**Submission
No 37**

INLAND RAIL PROJECT AND REGIONAL NSW

Submission to Inland Rail project and regional NSW

1.5 Narromine to Narrabri corridor

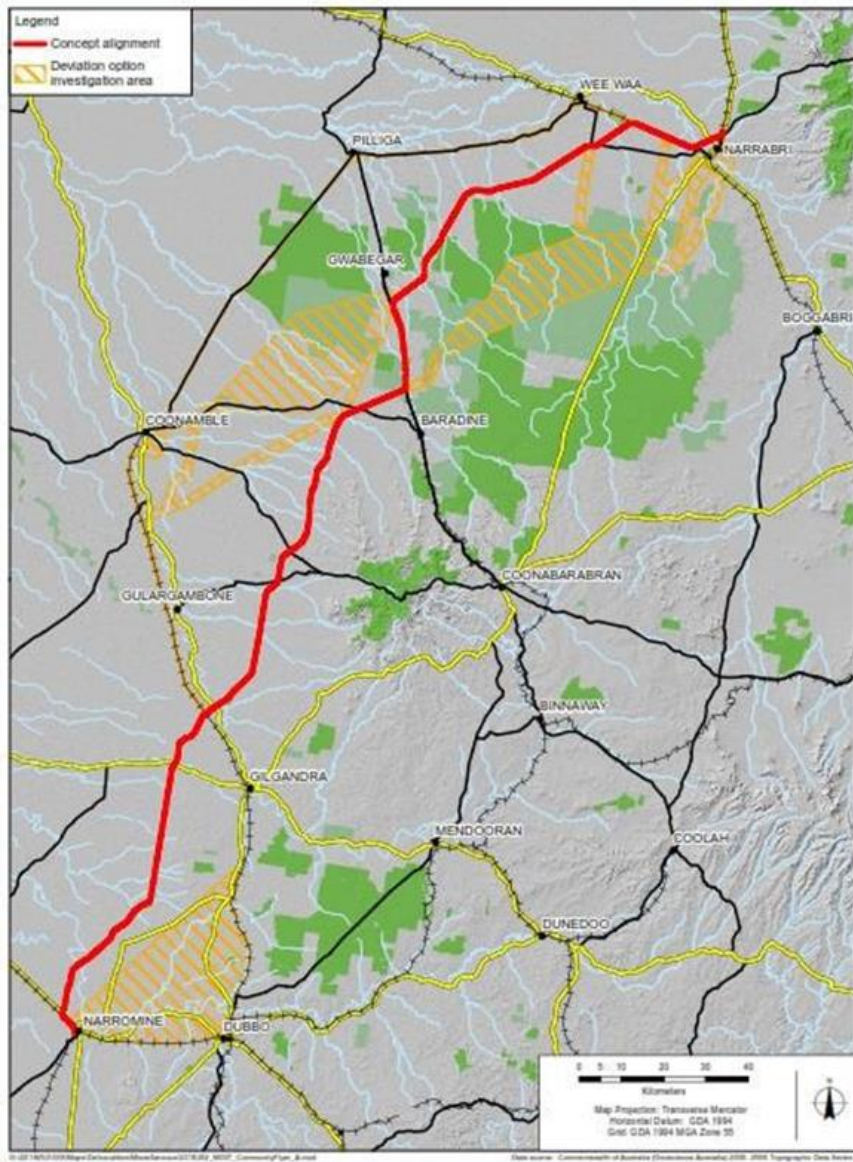
A major issue is apparent with this map.

All the farms and residential estates south of the existing Dubbo to Narromine rail line are outside the ‘deviation option investigation area’. There is also a large gap, over 10km wide between South Eumungerie and Gilmores Roads with no way to join the ‘deviation’ area with the concept alignment.

This map formed the basis of the ‘fact sheet’ that was put in landholder mailboxes in March 2017. Landholders South or East of Narromine who read this ‘fact sheet’ would never consider the Inland Rail project impacting their properties unless they were directly adjacent the Parkes to Narromine rail line.

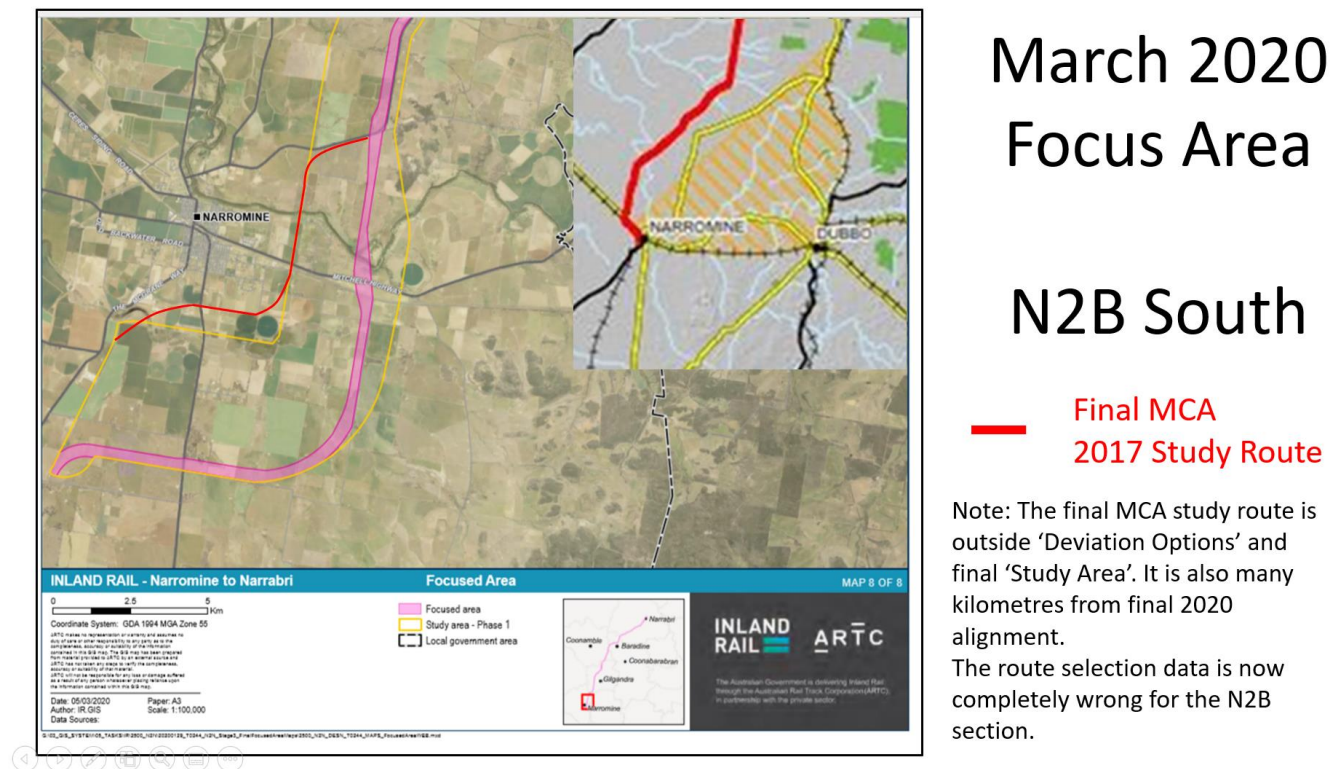
Issue 9) The Map below is compiled by overlaying the final MCA 2017 study alignment over the 2018 approved study area and 2020 focus area, an insert of the MCA deviation study area is also provided on the right.

As can be plainly seen, the Final 2017 MCA study route is outside the Ministerially approved 'Study area phase 1'.

It is also a very long way from the Focus area where the EIS alignment is now located. Any field work or desk top evaluations undertaken for the N2B MCA are inaccurate and I submit, invalid. The MCA alignment study area is not only outside the Ministers approved study area, it is on the Northern side of the Backwater Cowal on a completely different landform. This impacts all MCA scores – cost, flood exposure, Geotech/constructability, biodiversity, cultural heritage assessments. Note how far outside the 'Deviation option investigation area' the Focused area is, approximately 10km further South. Impacts on the MCA score include:

Figure 3-3 Parkes to Moree overview

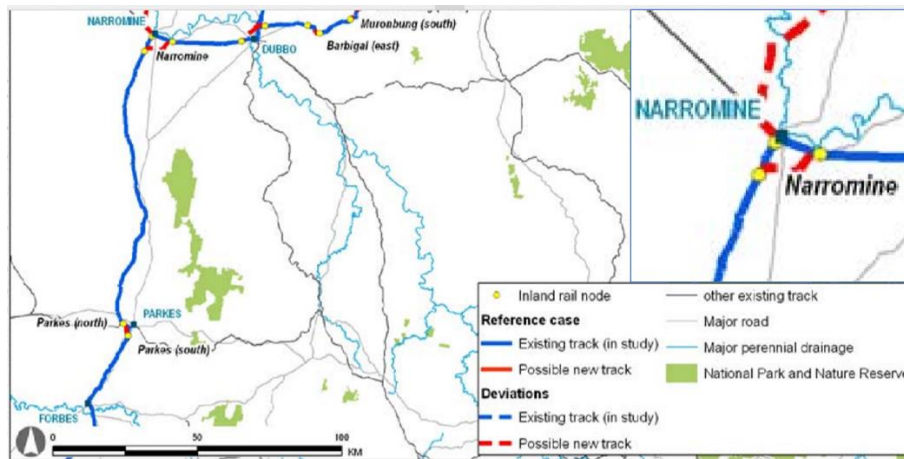
As can be plainly seen the IRAS 2010 ‘Eastern alternative route’ is very similar to current EIS route around Narromine. The 2016/17 MCA documentation never disclosed that the 2010 IRAS study had:

- evaluated the same alignment option south and south east of Narromine; and
- the IRAS report reached a completely opposite conclusion from a flooding and constructability perspective.

This is a significant omission by ARTCs MCA process.

Figure 3-1 Narromine to Burroway options

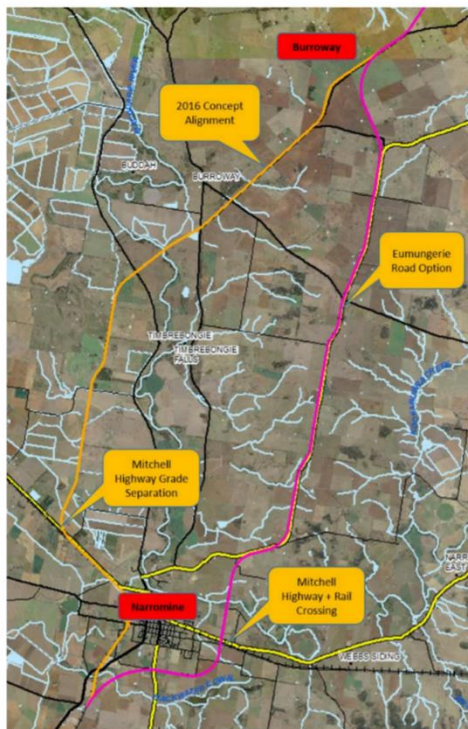
Incorrect
49km & 34 mins

Geotec not
accurately assessed
see ARTC own limitations
statements

Incorrect
2020 Eumungerie
Option 1% AEP
exposure is 16 km

Alignment length: The Eumungerie Rd option alignment length quoted by the MCA is not representative of the final EIS alignment which is now 49 km. If consultation with local landholders had occurred regarding this corridor proposal it would have become immediately apparent that the Pink line was not tenable from a flooding and land use perspective (NB this is a historically proven point as the alignment was moved sometime between May & October 2017).

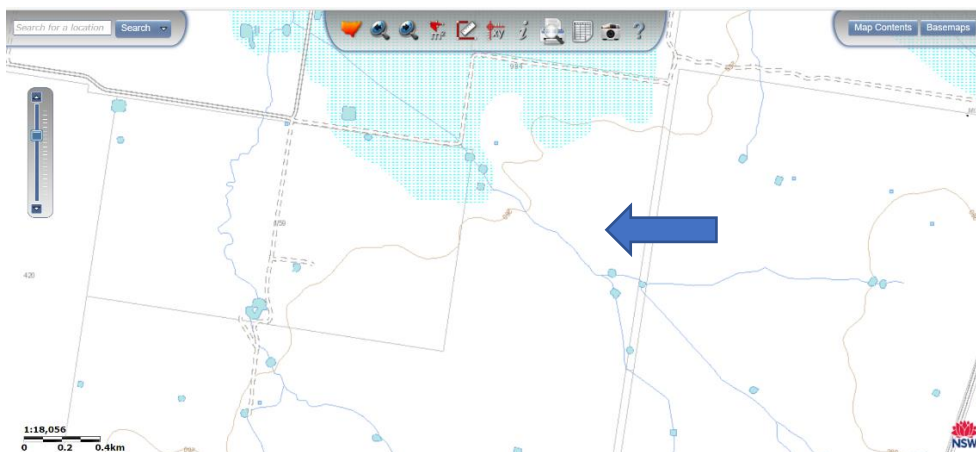
- The North – South running Inland Rail N2B alignment is positioned in the middle of the Webbs Siding outflow.
- An existing East – West rail embankment sits between the outflow origin (the Macquarie River) and its destination (the Backwater Cowal).

- The embankment has limited culvert drainage to relieve outflow flood waters.
- The embankment is assumed to be able to hold back the flood waters despite being comprehensively overtopped by ARTC own March 2020 flood model (a model which excludes town levee construction afflux and 23% climate change rainfall escalation).

Photos 4th April 2020.

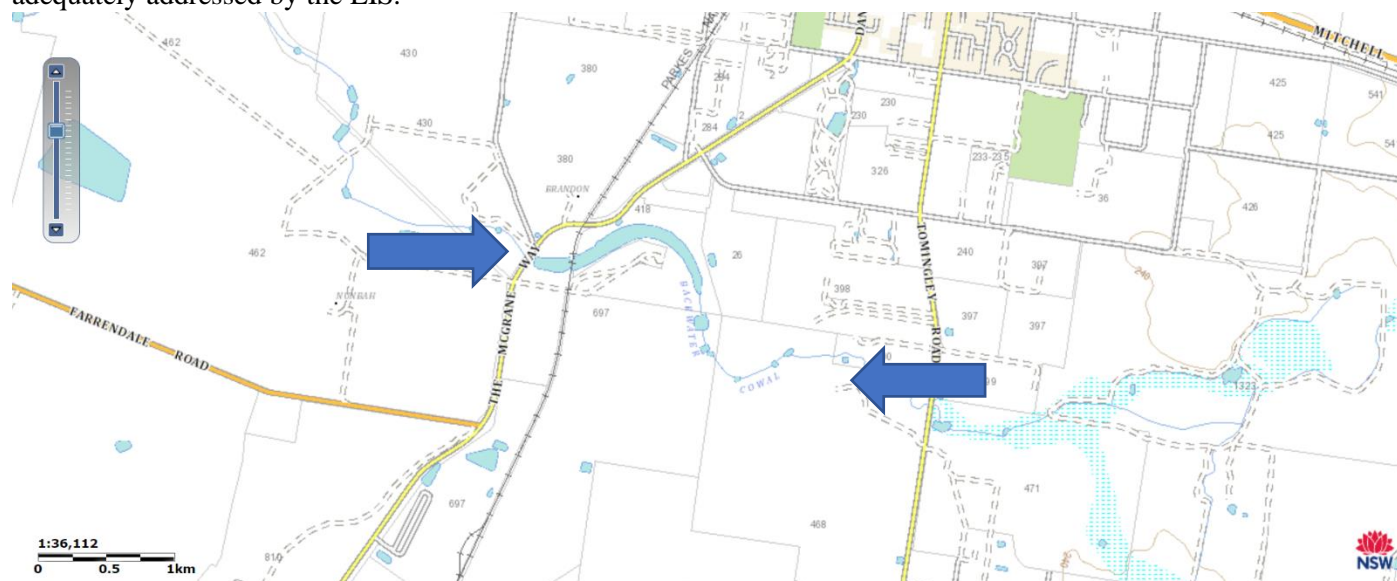
It contributes substantial flooding to the Wallaby and Dappo Rd area.

Flooding result on Webb Siding Rd looking W.

Un named 3rd order crossing Wallaby/Dappo Rd intersection. Photo looks NE toward Webbs Siding outflow route.
